**SIB 65 27 24**

**KNEE AIR BAG CCM G05 VARIANT WIRE HARNESS REPAIR**

2025-11-25

This Service Information Bulletin (Revision 1) replaces SI B65 27 24 **dated October 2024**.

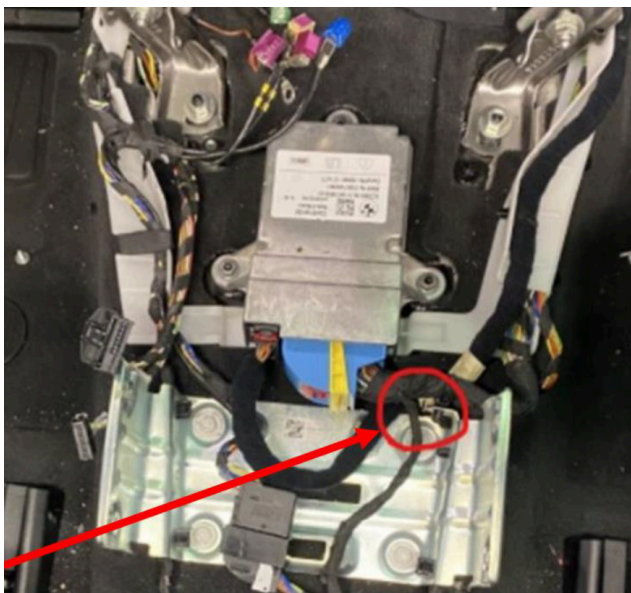
2- Remove the **center console** as per **Repair Instructions 51 16 165** to access the Air Bag Control Module **A11 (ACSM)** wiring connector (**A11\*2B**).

Check the ACSM module for signs of corrosion within the electrical connector.

**NOTE:** The LCI (life cycle impulse, aka “facelift”) models change the design of the ACSM air bag control module, wire location, connector number. **DO NOT FOLLOW THIS BULLETIN FOR LCI VEHICLES.**
